**DESIGN REVIEW & PRESERVATION BOARD**  
**1231 "T" Street - SACRAMENTO, CALIFORNIA 95814**

LOCATION: 814 25th Street

PROPOSAL: The applicant proposes development of a two-story duplex in the Boulevard Park Preservation Area

PB 86-013

SOUTH ELEVATION

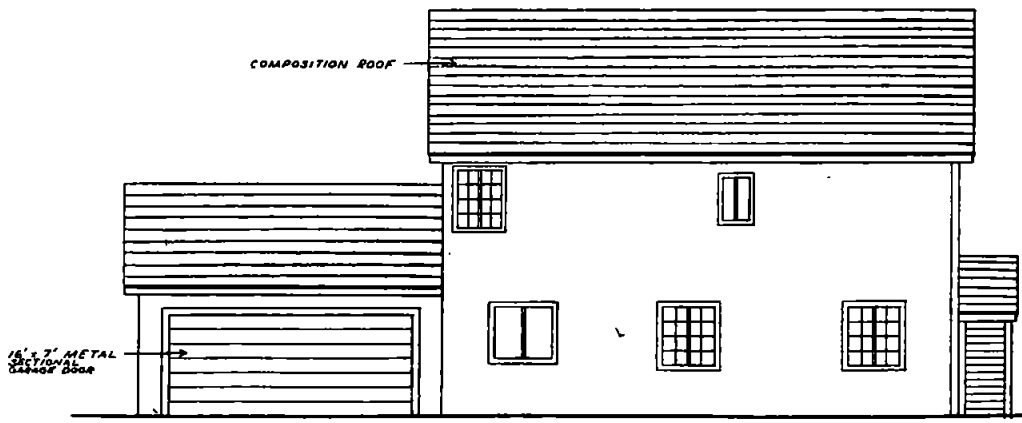
4. The fenestration on the alley (south) elevation could be greatly improved. The kitchen window toward the rear should have lites for consistency with other windows. The master bedroom window should be centered on the kitchen window below. Another window for bedroom #2 centered over the living room window could be added to further improve the fenestration.
5. The applicant proposes sliding aluminium windows. Double hung or single hung windows with window sill would be preferable considering the surrounding structures and location in the Boulevard Park Preservation Area.
6. The placement of the second floor rear balcony is much improved in that it is not visible to public view.
7. No colors have been submitted.
8. Fencing is proposed to be 1" x 6" board. Wing fencing in the front of the building should be stepped back from the building face at least one foot.

EAST ELEVATION

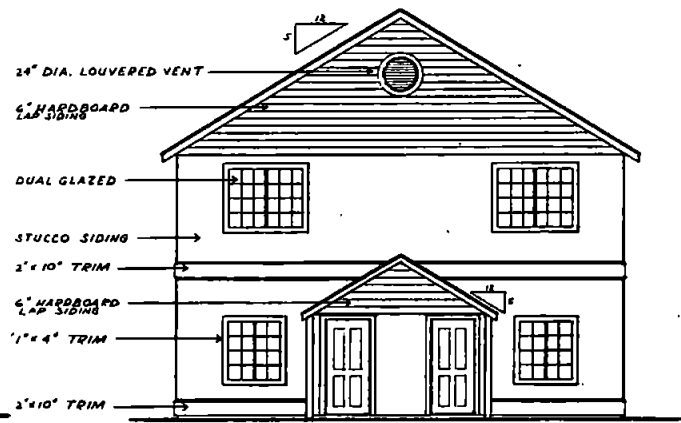
The front porch is weak in scale relative to the overall front (east) elevation. Raising the porch and slightly increasing its frontage, and increasing the fascia board width would strengthen the porch element.

The lower trim board should be continued between the entry doors.

Staff questions the appropriateness of fully enclosing the porch end.

The raised porch does not necessitate a raised foundation. Rather, a step down from a raised interior entry area to the living room will be needed.

1. The front elevation shall be redesigned with a raised porch with a wider frontage and with a wider fascia on the porch roof. The lower trim board shall be continued between the entry doors. The redesign shall be subject to review and approval by staff.
2. Windows shall be double hung or single hung and shall have window sills. Windows may be wood prepainted aluminum. The design shall be subject to staff review and approval.
3. Kitchen windows shall have lites.
4. *The/master/bedroom/window/on/the/alley/(south)/elevation/shall/be/centered/over/the/kitchen/window/*
5. *An/additional/window/for/bedroom/#2/of/the/alley/width/shall/be/provided/centered/on/the/living/room/window/below/*
6. Colors shall be subject to review and approval by staff.
